**BUNDABERG REGIONAL COUNCIL
CHANGE APPLICATION – MINOR CHANGE DECISION UNDER
DELEGATED AUTHORITY**

APPLICATION NO.	526.2018.68.1
PROPOSAL	Change Application for Minor Change - General Business
APPLICANT	Janam Pty Ltd
OWNER	Janam Pty Ltd
PROPERTY DESCRIPTION	Lot: 900 SP: 261837
ADDRESS	106 FE Walker Street KEPNOCK
PLANNING SCHEME	Bundaberg Regional Council Planning Scheme 2015
ZONING	District Centre Zone
OVERLAYS	Acid sulfate soils, Airport and aviation facilities, Flood hazard, Infrastructure, Steep Land
ORIGINAL APPLICATION NO.	322.2016.45820.1
DATE OF ORIGINAL DECISION	2 November 2016
DATE CHANGE APPLICATION RECEIVED	13 August 2018
PROPERLY MADE DATE	1 November 2018
STATUS	The 20 business day decision period ends on 29 November 2018
REFERRAL AGENCIES	Department of State Development, Manufacturing, Infrastructure and Planning
SITE INSPECTION CONDUCTED	23 August 2018
LEVEL OF DELEGATION	Level 3

This Decision Notice includes change approved on 21 December 2018.
Changes are in ***bold italics***.

JANAM DEVELOPMENT PROJECTS
KEPNOCK CENTRAL, BUNDABERG
LANDSCAPE CONCEPT PLAN
GROUND LEVEL PLAN - SHEET 1

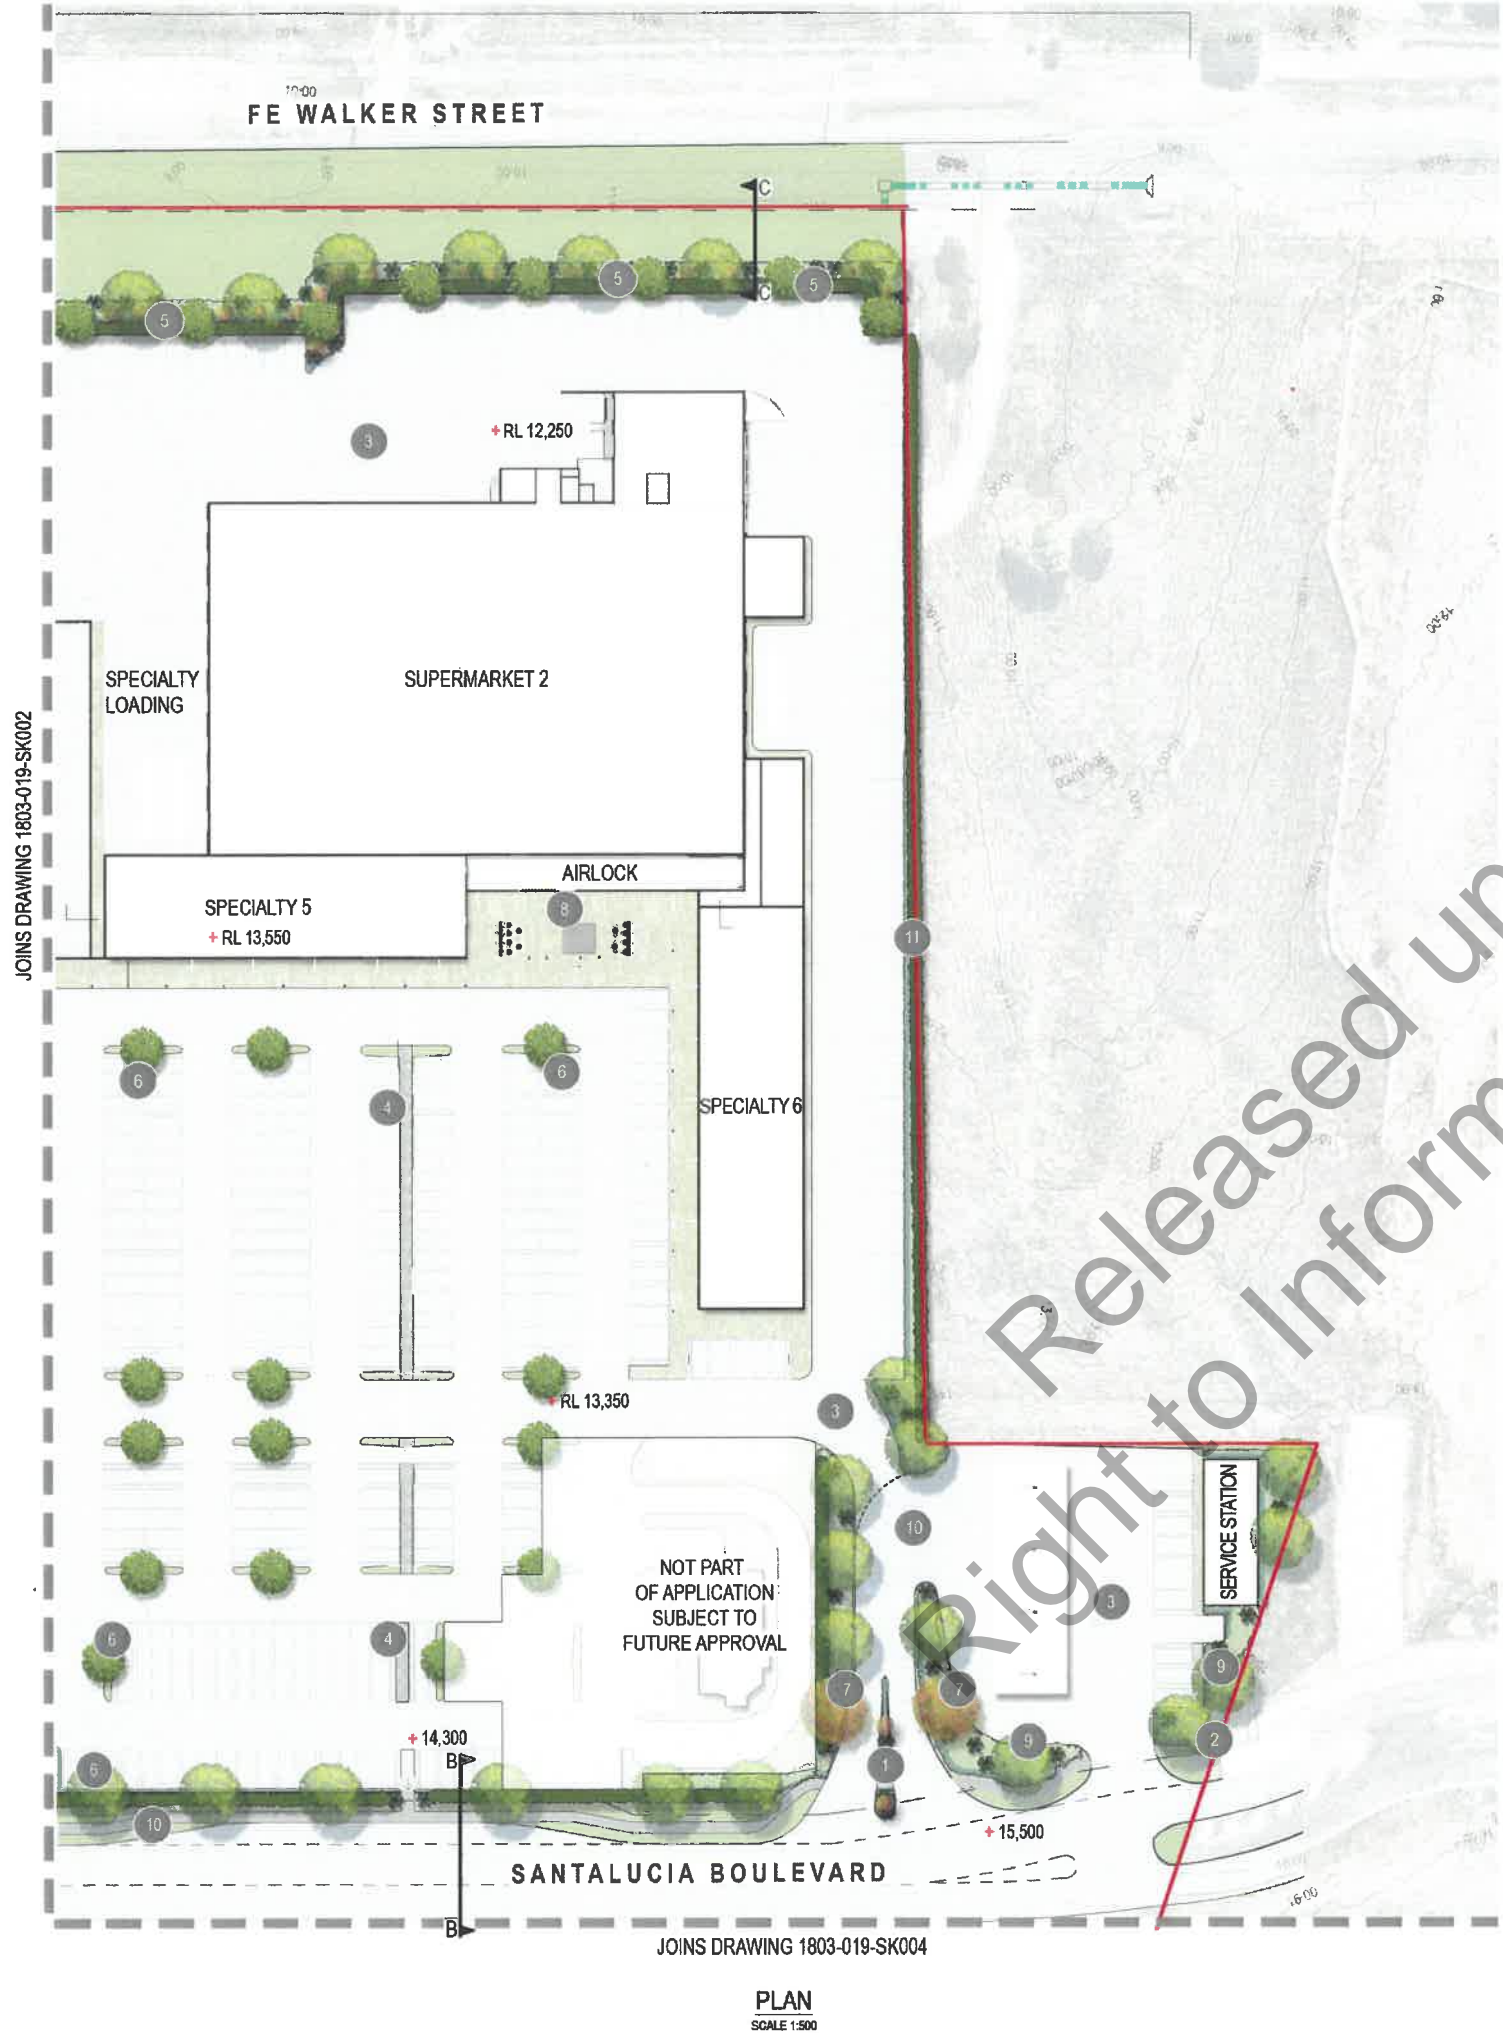
- p. Amendments to the landscape buffer to the north of Stage 1 to:
 - i. Include melaleucas in the inundation area identified as '7' **in the key of 'Landscape Concept Plan Ground Level plan – Sheet 1, drawing no. SK002 Rev A and prepared by LAUD Ink**, at a density that will result in a minimum of 50% of the Stage 1 elevation to FE Walker Street being screened by vegetation, upon maturity, **generally in accordance with Elevation – Sheet 1 (North Elevation) Plan, drawing no. SK020 Rev A prepared by LAUD Ink**. Trees must be placed either side of the pipe and provided with appropriate root barriers; or

- aa. Clear trunked canopy shade trees are to be provided to the full extent of the edges of the car park area for a width of 3m as shown on **plans SK002 Rev Dated July 2018 and SK003 Rev A dated July 2018 prepared by LAUD Ink.**

JANAM DEVELOPMENT PROJECTS
KEPNOCK CENTRAL, BUNDABERG
LANDSCAPE CONCEPT PLAN
GROUND LEVEL PLAN - SHEET 3

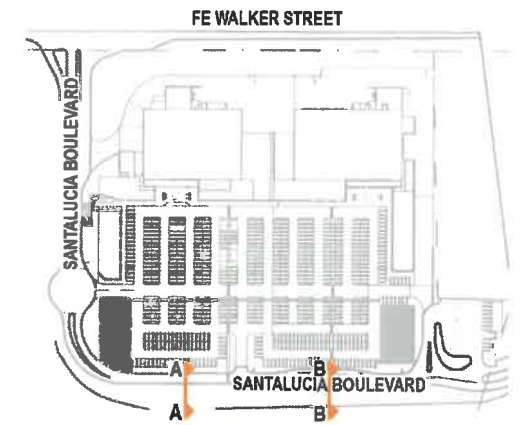
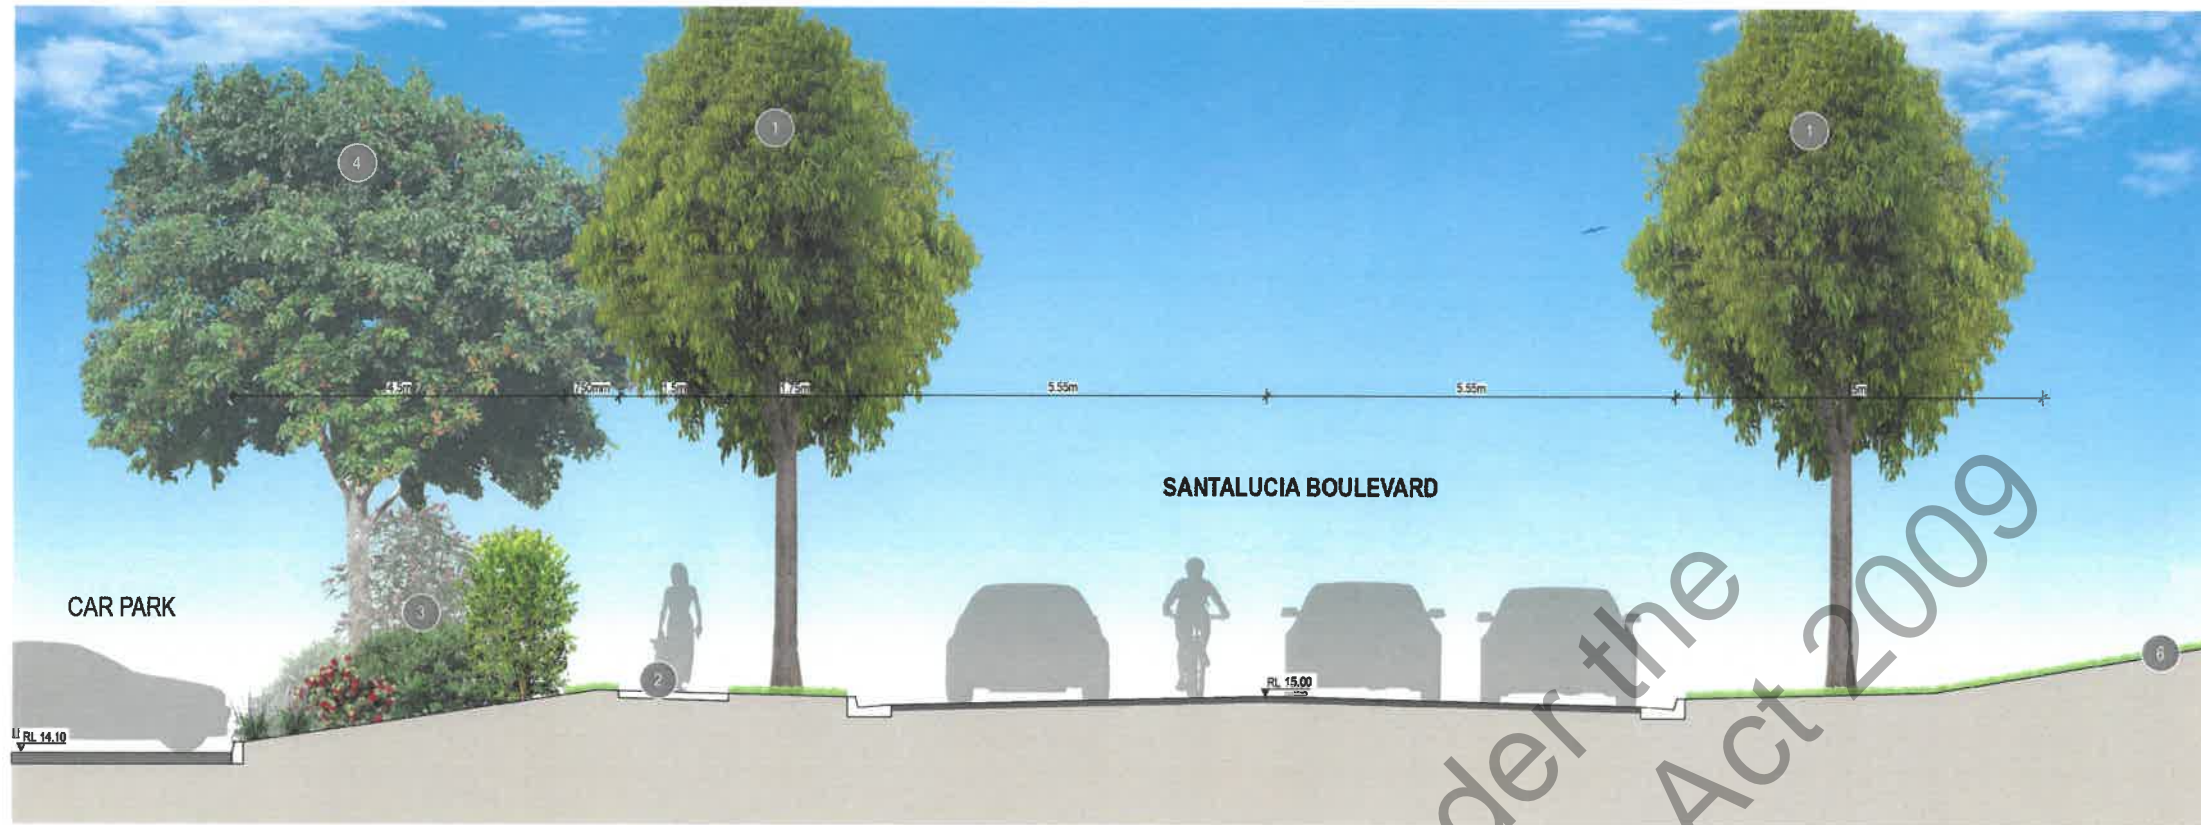
- o. Landscaping to the full length of the site's southern property boundary in association with the first Stage of development, with trees to be provided as detailed in **Ground Level Plan – Sheet 3 (notation 4) drawing no. SK004 Rev A and prepared by LAUD Ink dated July 2018;**

Below is an extract from the 2d stormwater model and displays the depth of flow at FE Walker St at the area of interest.

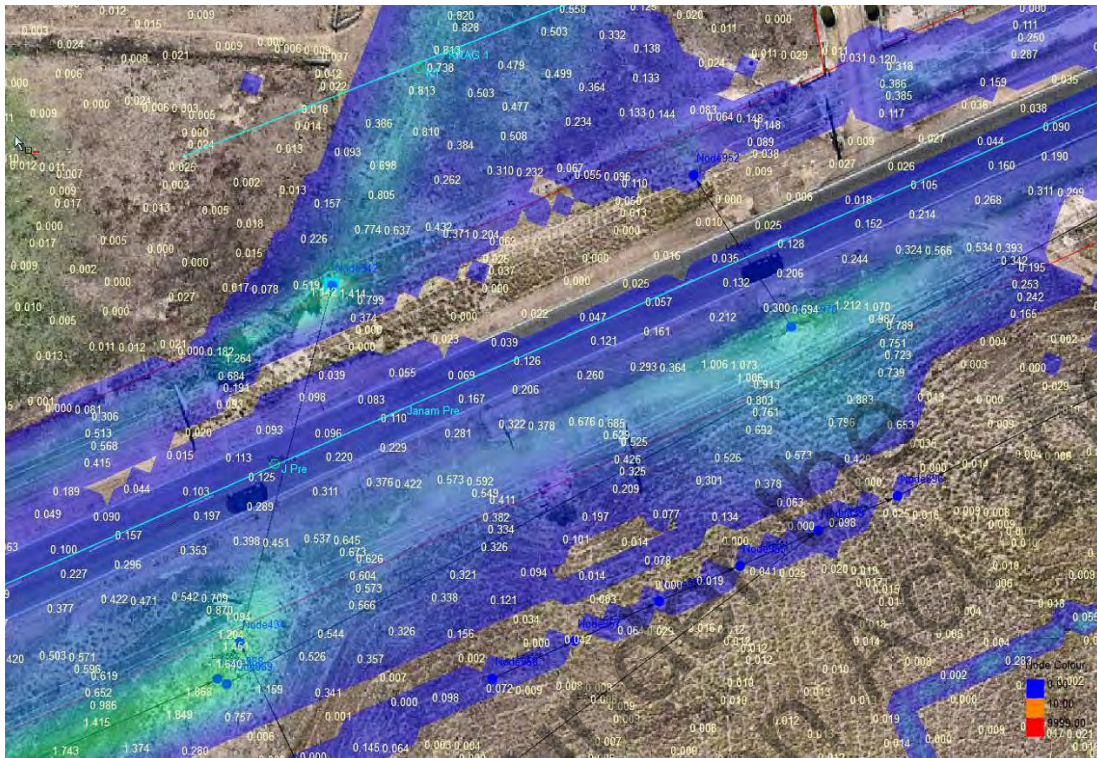
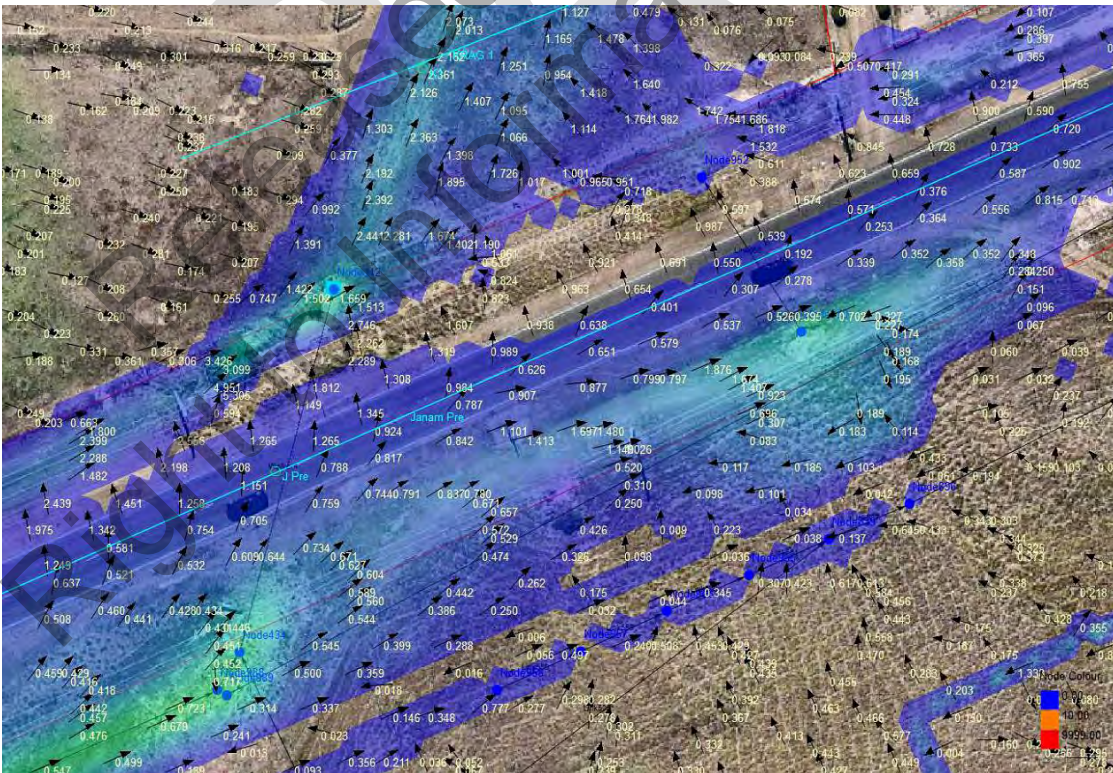
The numbered values relate to the locations assessed in the depth velocity assessment table.
